APPENDIX C

HERITAGE REVIEW

Hornsby Aquatic Centre Redevelopment

WEIR PHILLIPS
Architects & Heritage Consultants

HORNSBY AQUATIC CENTRE **OPTION 2 – VEHICULAR 2-WAY DRIVE IN PARK** **EVALUATION OF POTENTIAL PARKLAND IMPACTS**

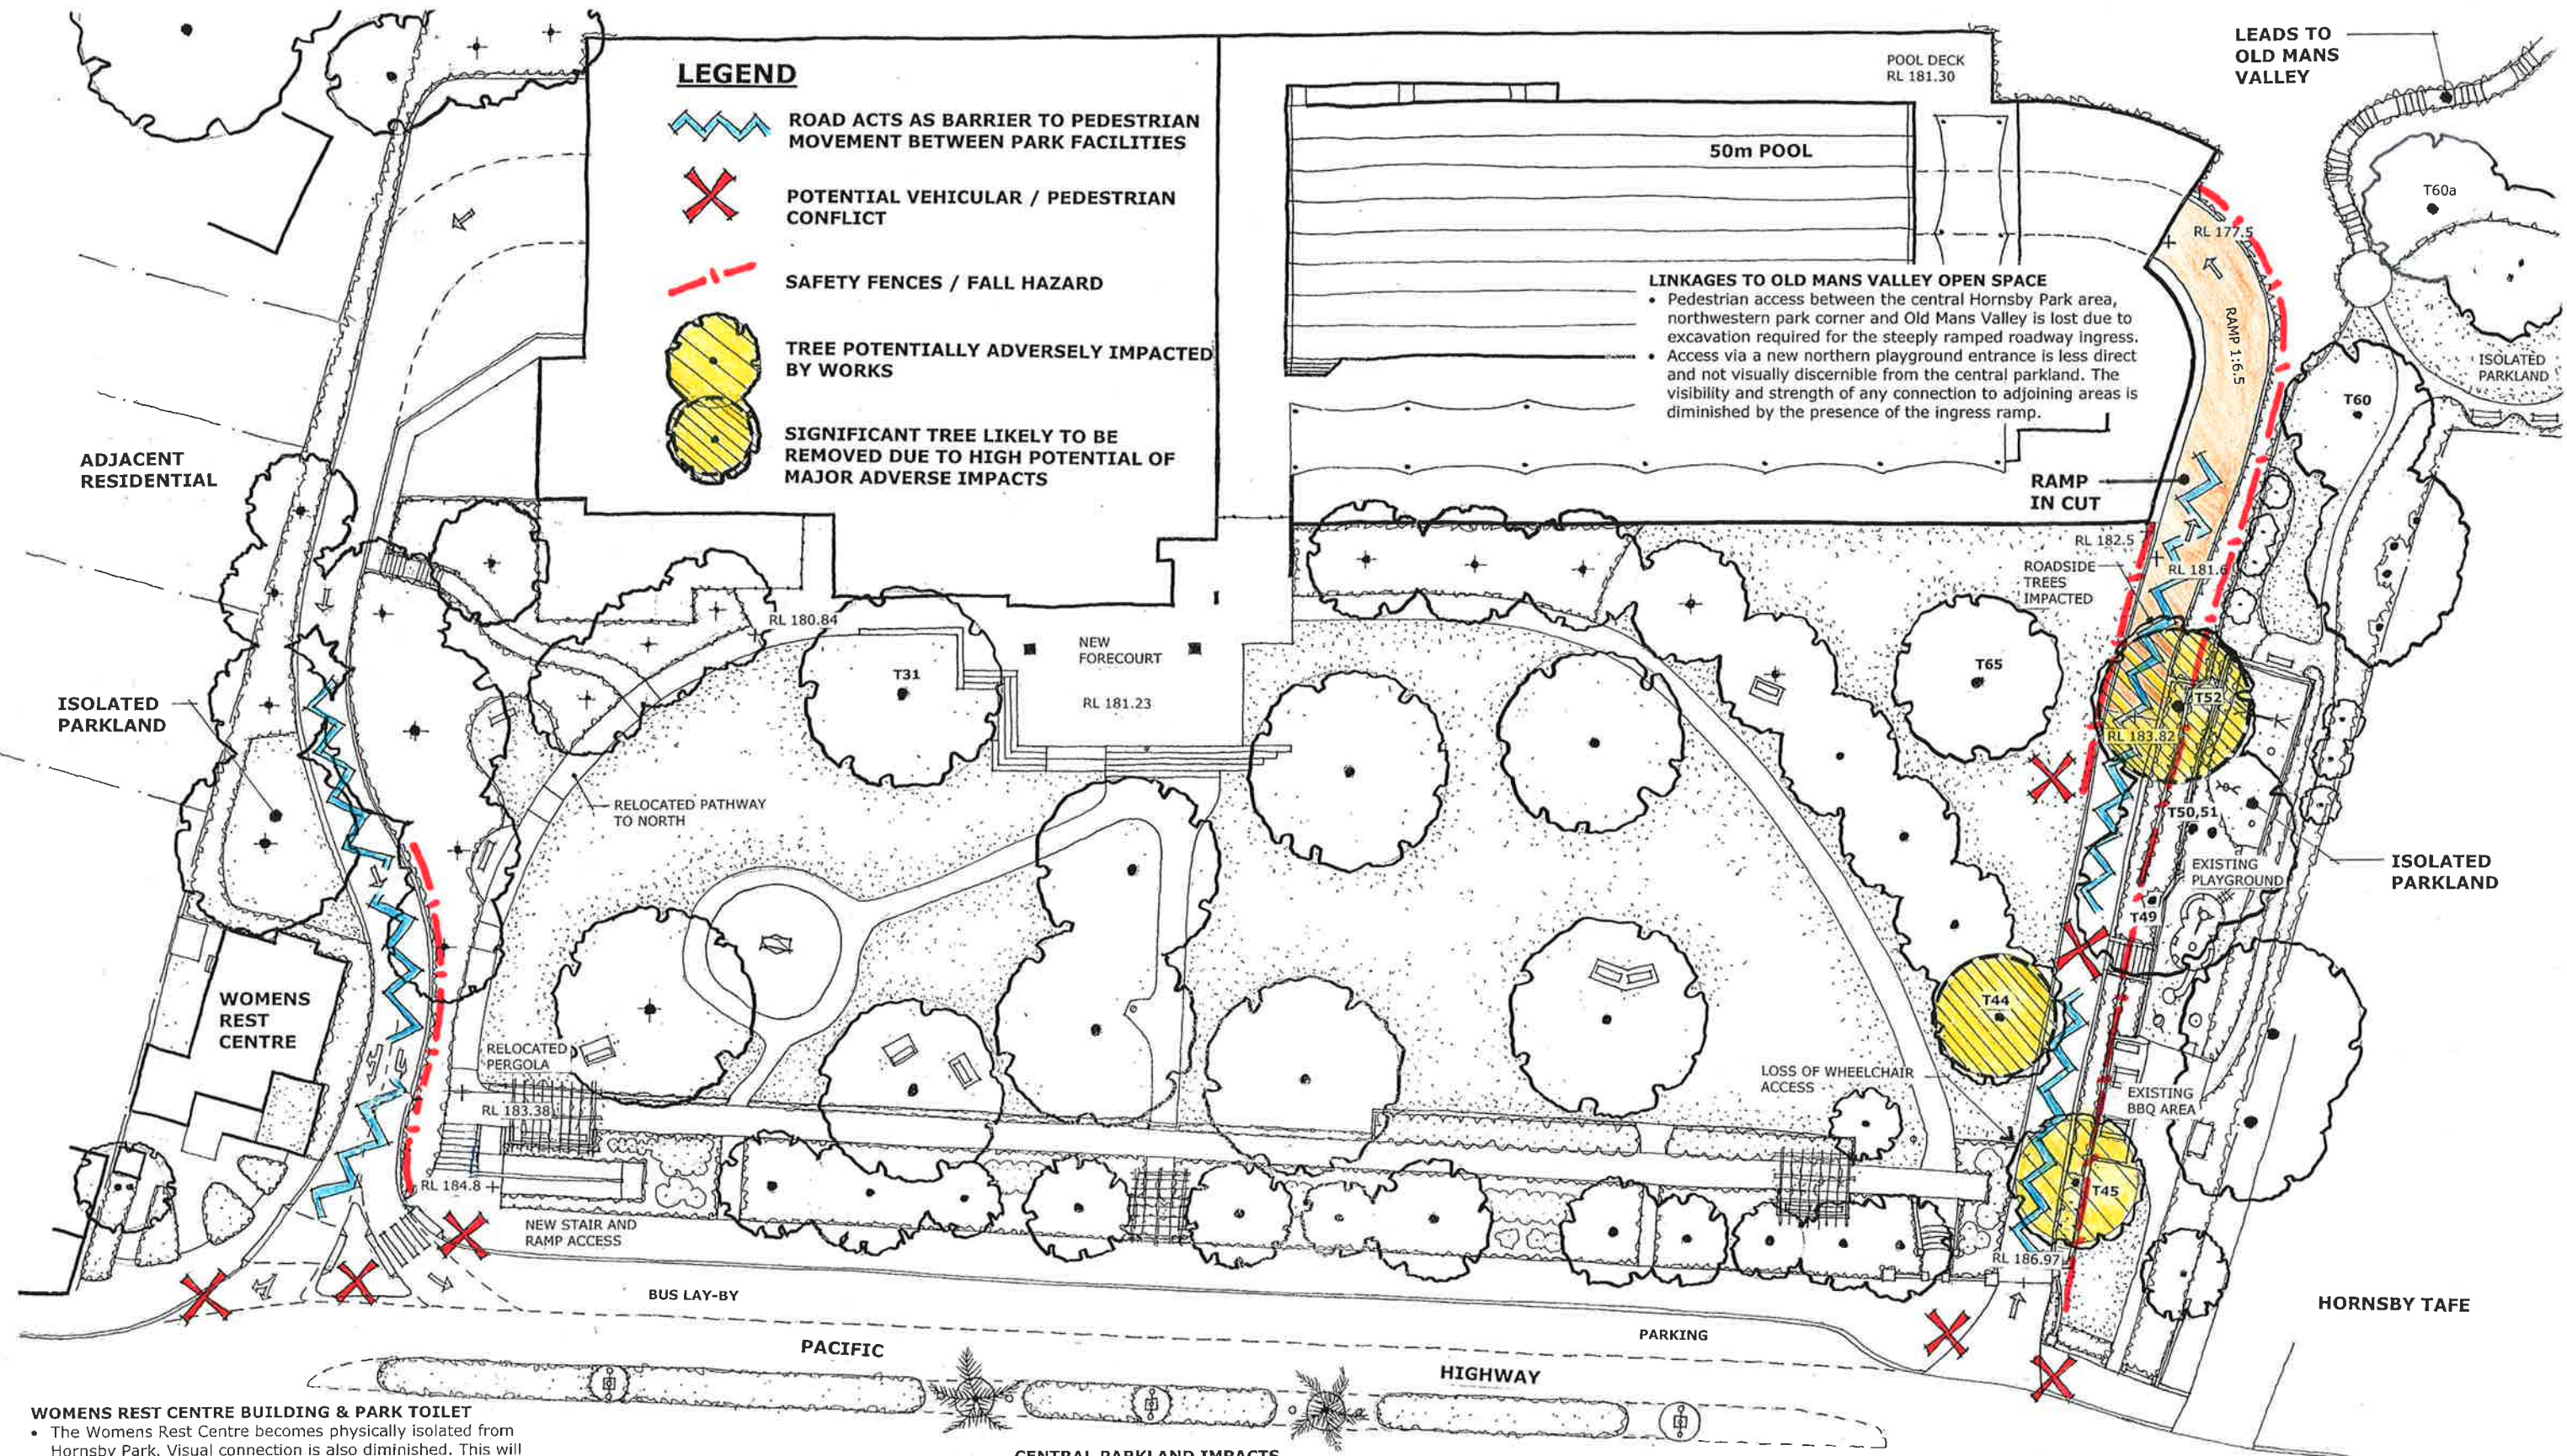
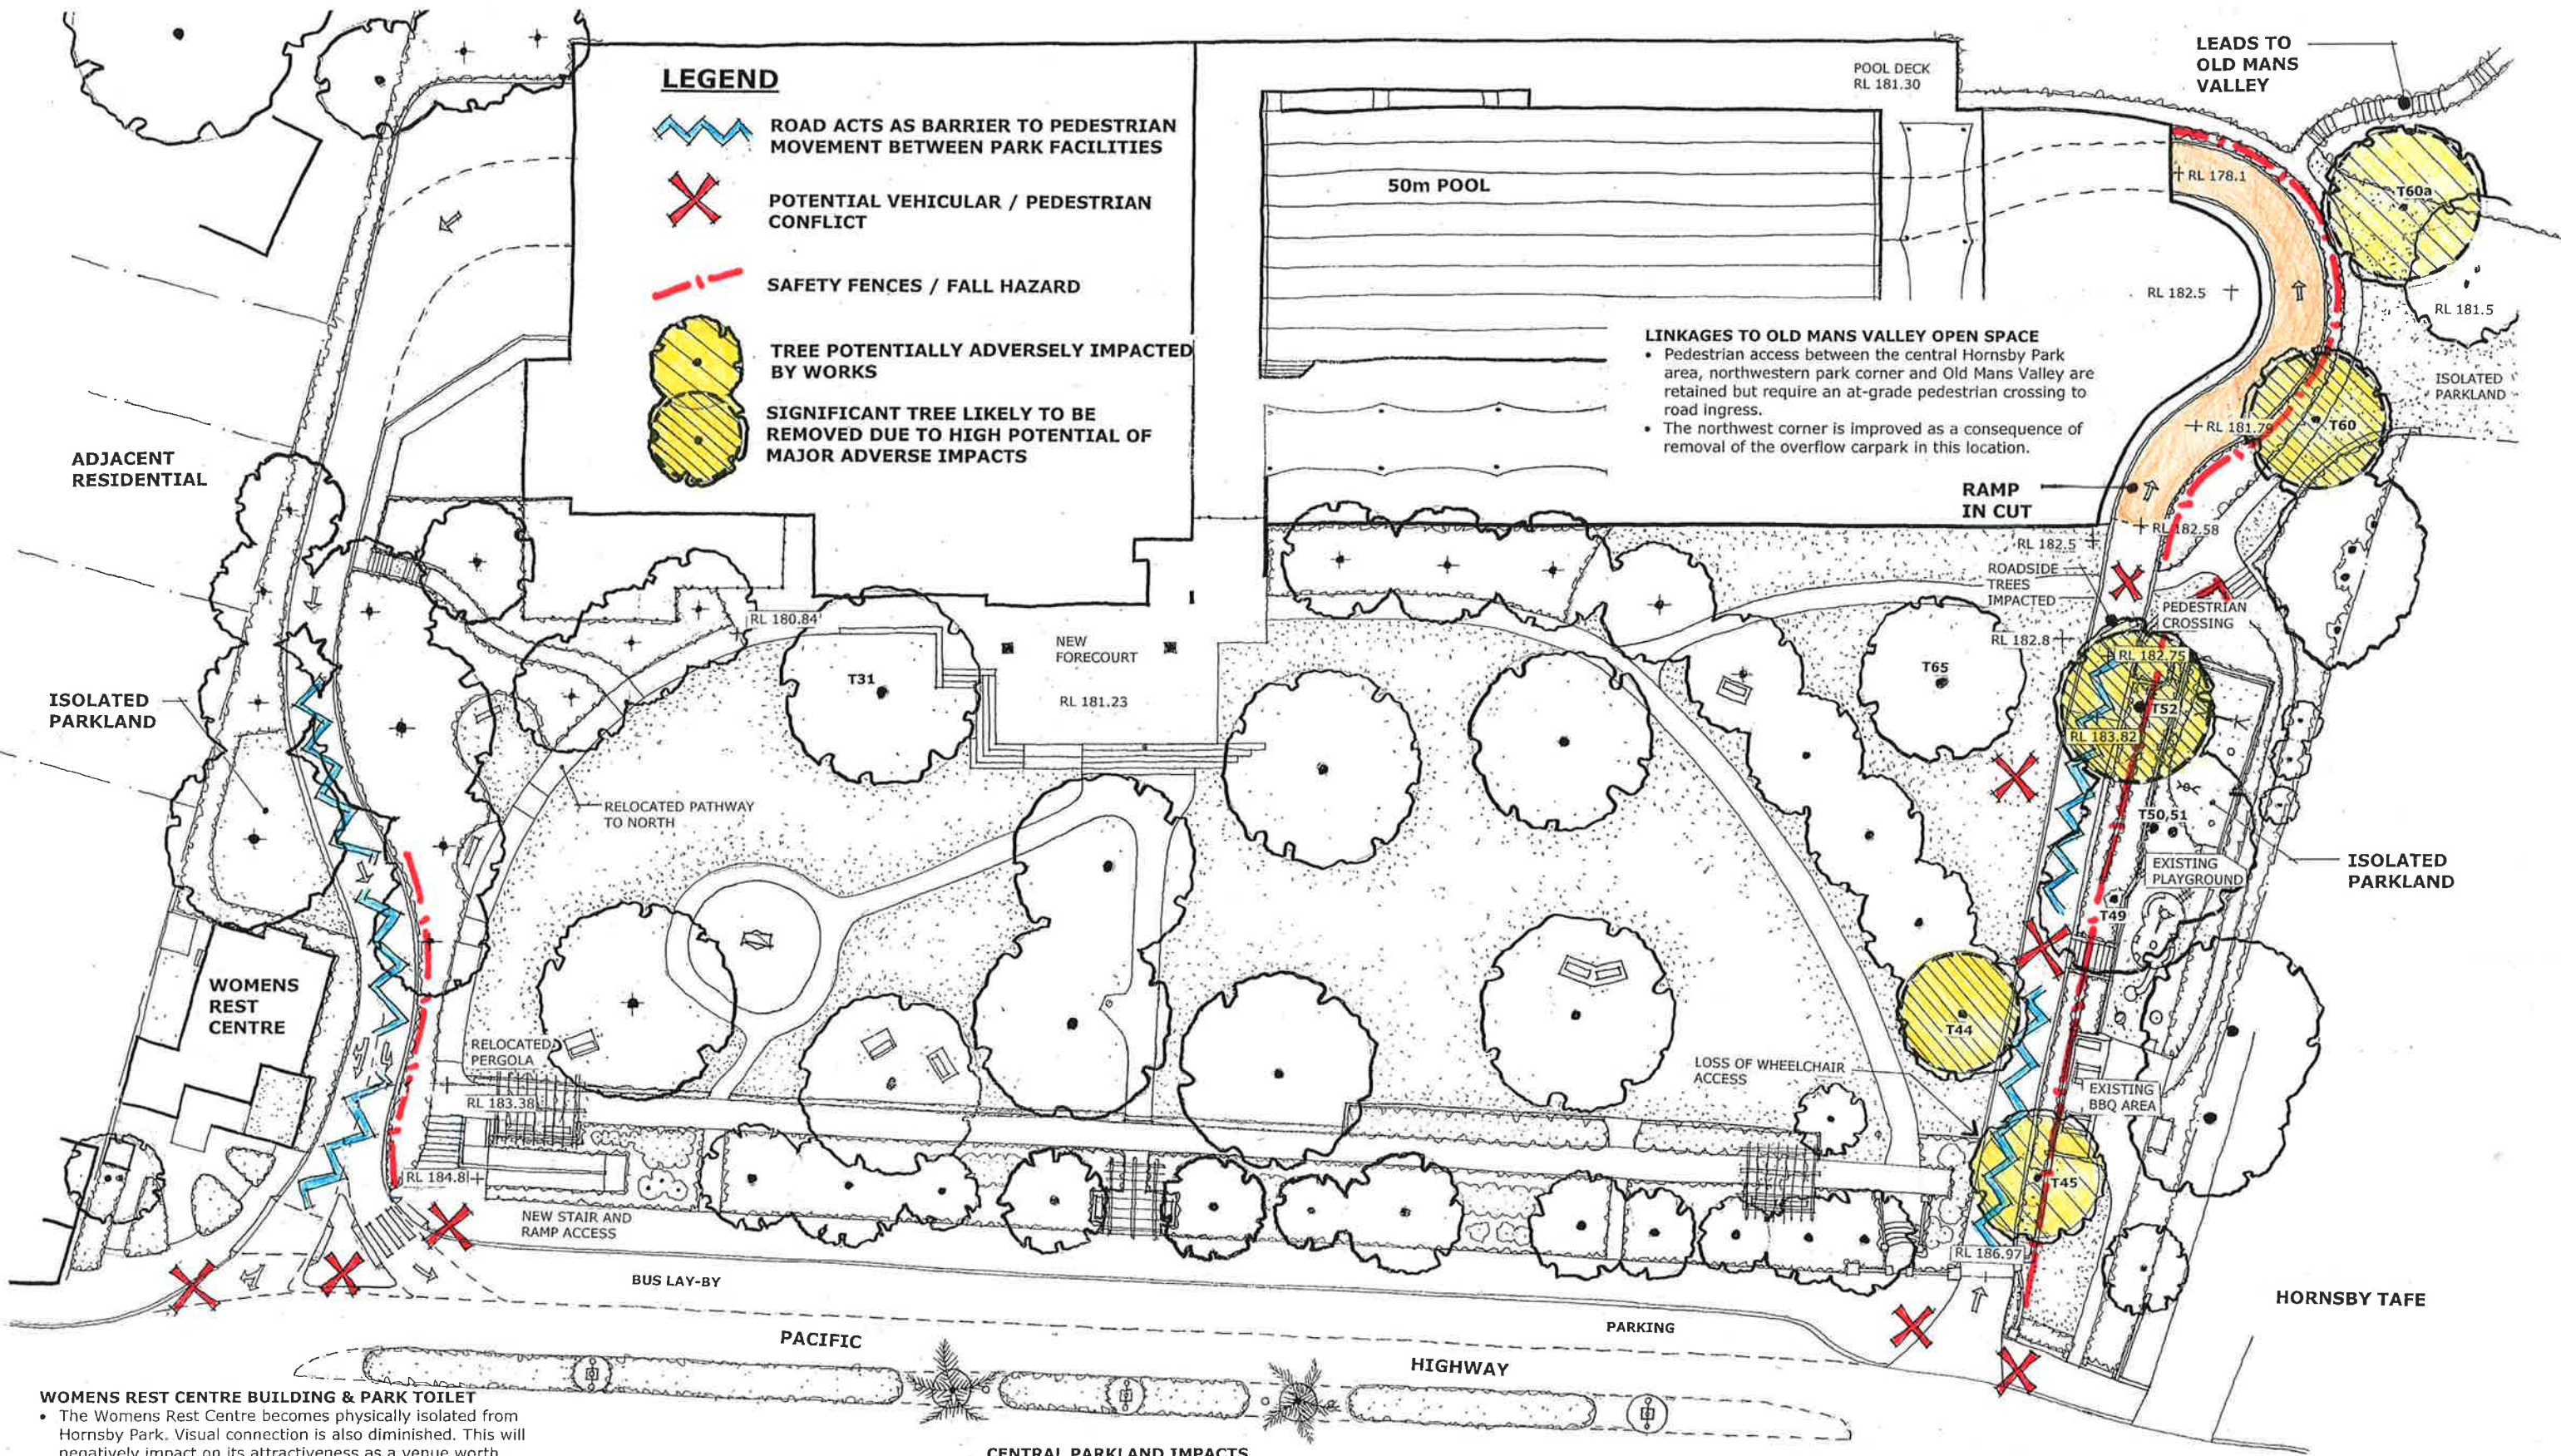
- Two access roads would be required rather than one, thus resulting in the loss of greater areas of open space than would be required by Option1 (Revised).

- Two significant trees would need to be removed from the northern end of the park.
- One of the existing sandstone gates in the northeast corner would need to be modified. Although not deemed to be significant, they do tell part of the story of social esteem in which the park is held.

- This option does not allow for a direct connection between the main section of the park and the stair to the bush valley beyond as provided for by Option 1 (Revised).
